# INTERNATIONAL STANDARD ISO 3184:1998 TECHNICAL CORRIGENDUM 1

## Reach and straddle fork-lift trucks — Stability tests

### TECHNICAL CORRIGENDUM 1

Figure 11

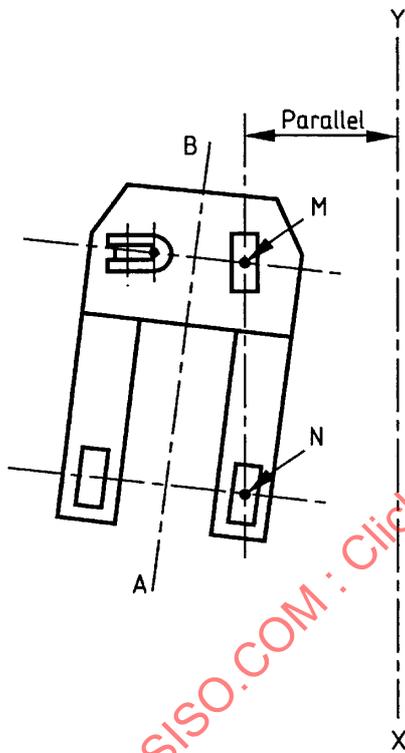
Replace Figures 11, 12 and 16 by the following corrected figures:
